DRAINAGE AND TRANSPORTATION INFORMATION SHEET (REV 11/2016)

Project Title: NM Beef Jerky Restaurant Building Permit #: _____ Hydrology File #: J140185
DRB#: _____ EPC#: _____ Work Order#: _____
Legal Description: Lot 4 Block 21 Albright i Moore Addn
City Address: 1425 4th St. NW ABQ NM 87102

Re: NM Beef Jerky Restaurant
1425 4th St. NW
Traffic Circulation Layout
Engineer's/Architect's Stamp 07-28-17 (J14-D185)

TCL
1 of 1

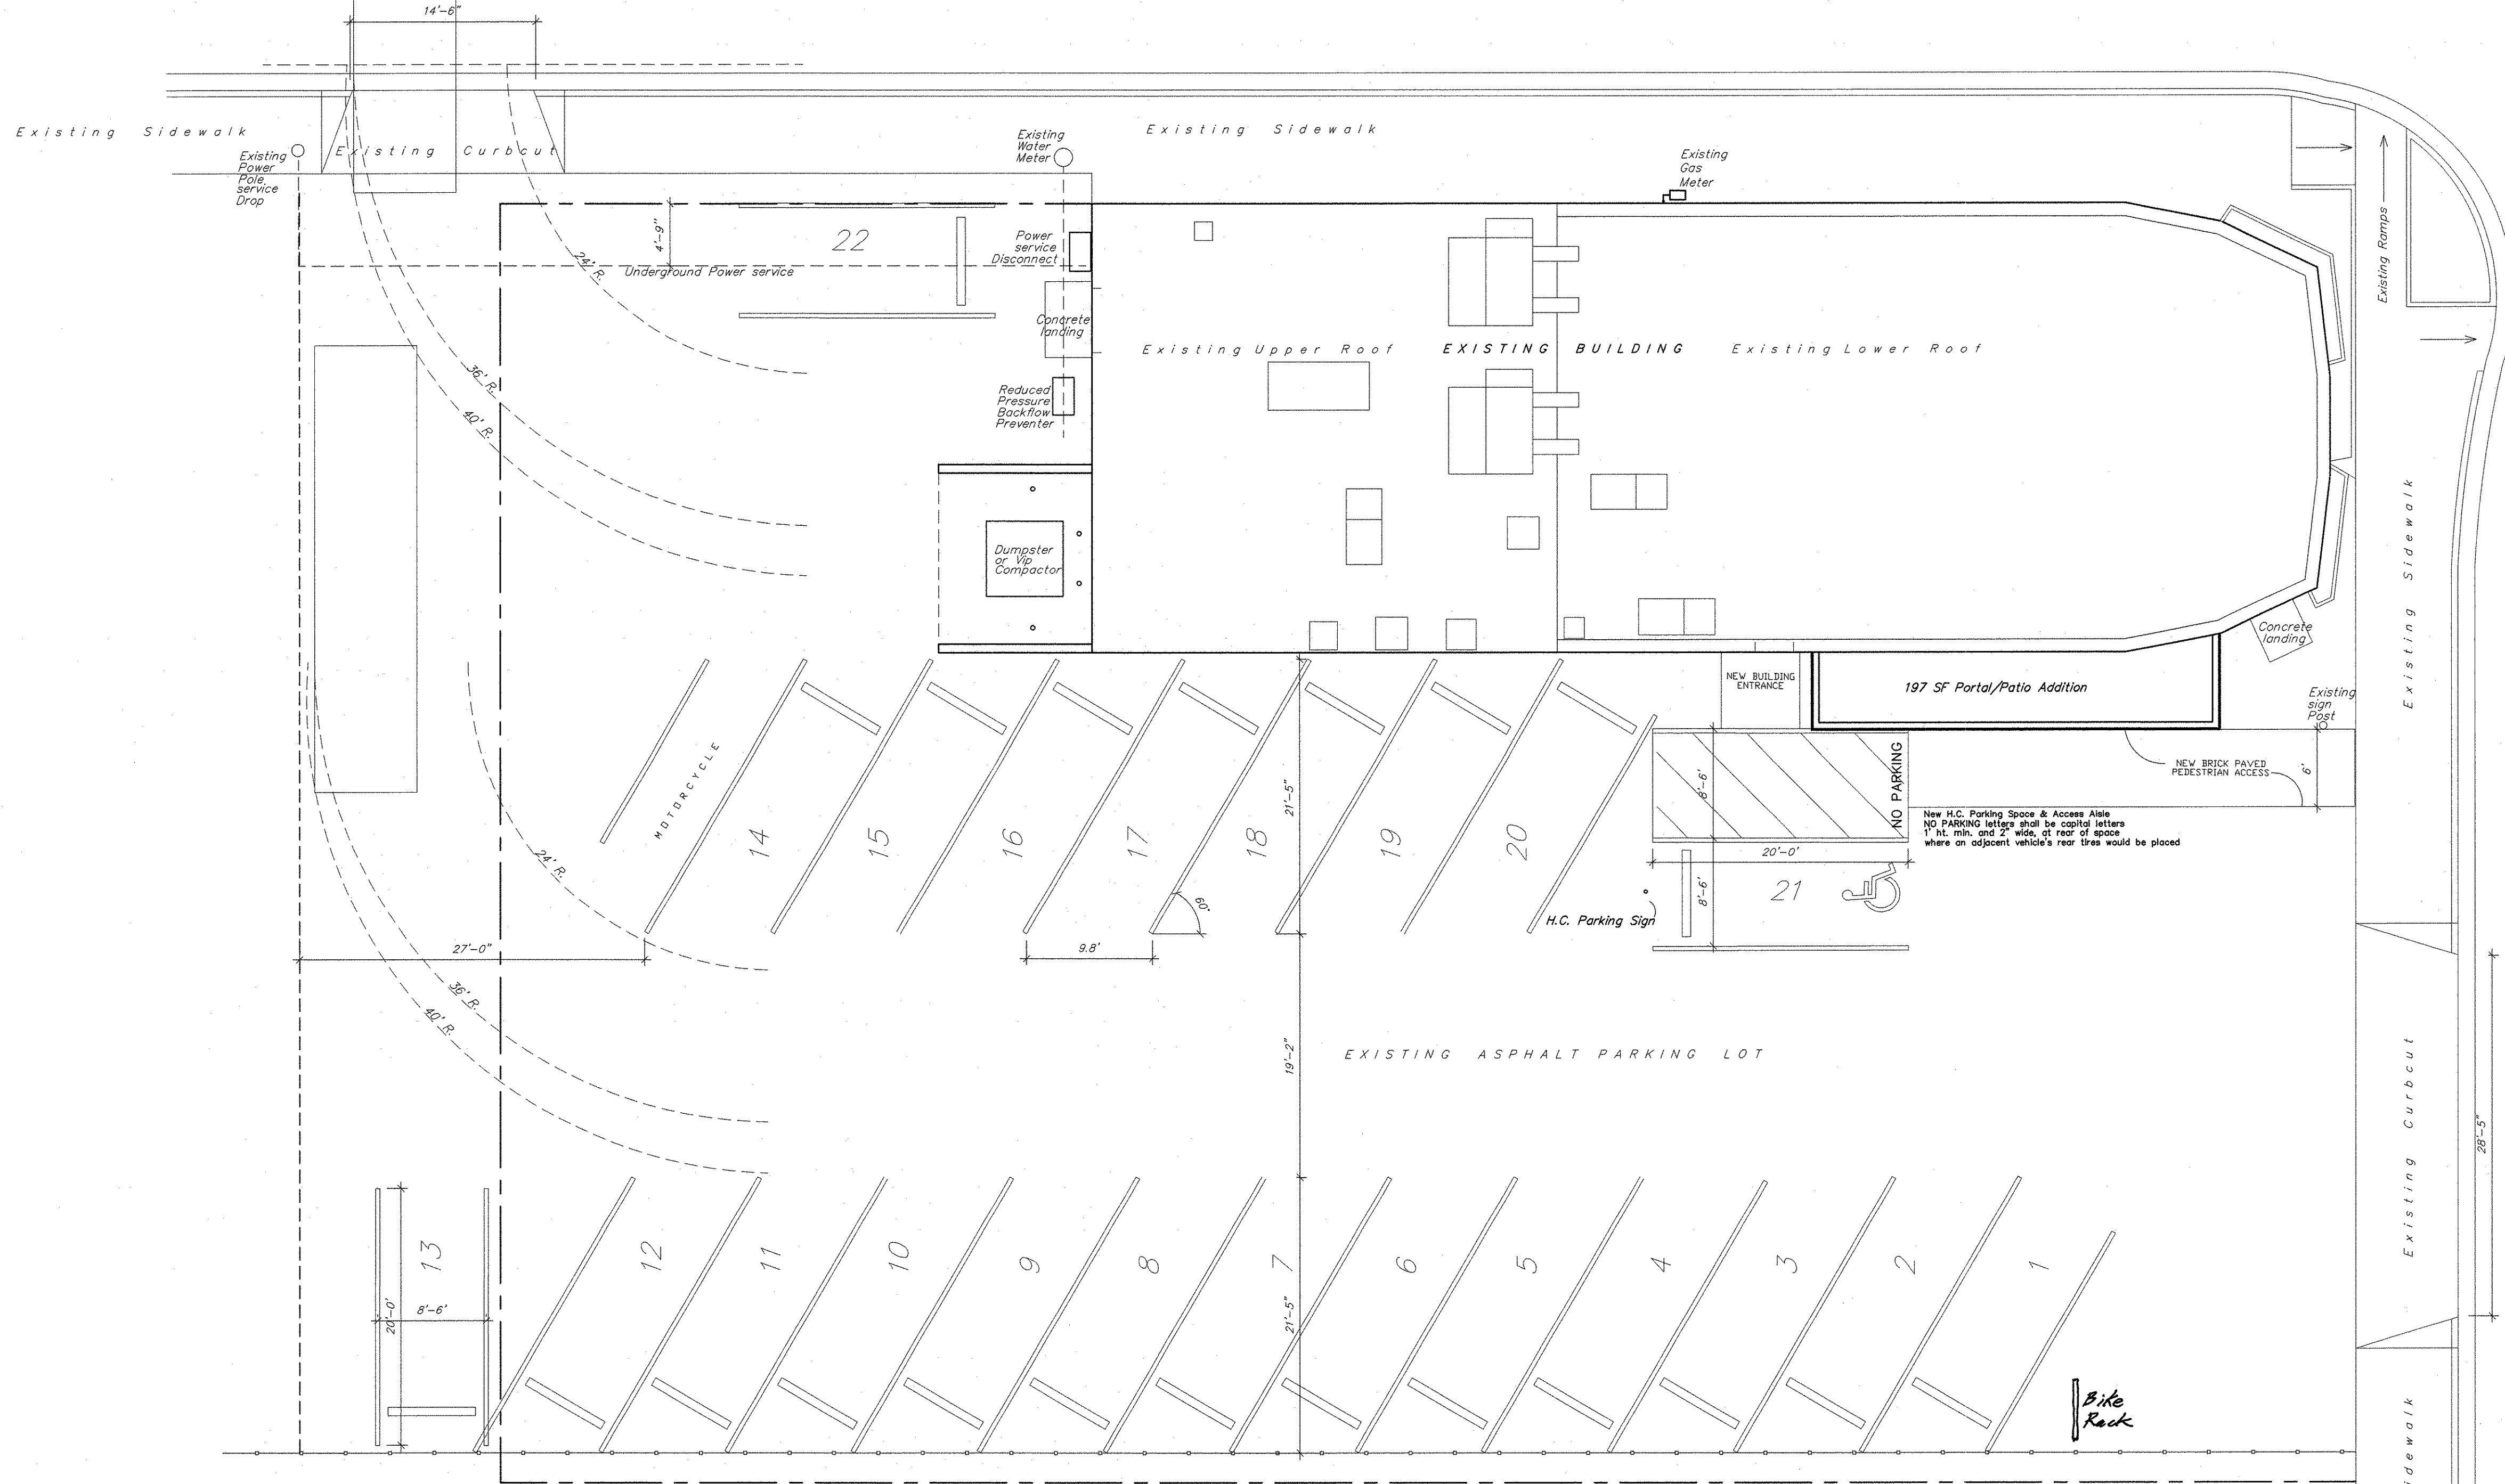
1. The scale must be shown on the plan. Per the Development Process Manual, Chapter 27, Section 2, Part B.1, on the following scales may be used:

1" = 20'
1" = 40' 1" = 50'
1" = 100' (for overall layouts only)

2. Identify the right of way width, medians, curb cuts, and street widths on Constitution Ave and 4th St.
3. Clarify existing property lines and proposed property lines.

4. Indicate if the new entrance will be flush with asphalt or provide ADA ramp.
5. It is not clear what the parking lot surface will be. Please provide the type of surface treatment.

6. Please list the width and length for all existing and proposed parking spaces. Some dimensions are not shown. The access aisle should be 24 feet for two way traffic. (may want to look at the lengths of the parking stalls they look to be over 20 feet long standard parking space can be 18 feet)

7. Provide a sign indicating the motorcycle parking.
8. Parking spaces cannot cross over lot lines. Parking spots must be inside the property line.
9. When accessing 4 or more parking spaces off the alley or use for refuse the alley must be paved per the zoning code. § 14-16-3-1 Off-Street Parking Regulations.

10. Work within the public right of way requires a work order with DRC approved plans.

11. Please add a note on the plan stating "All improvements located in the Right of Way must be included on the work order."
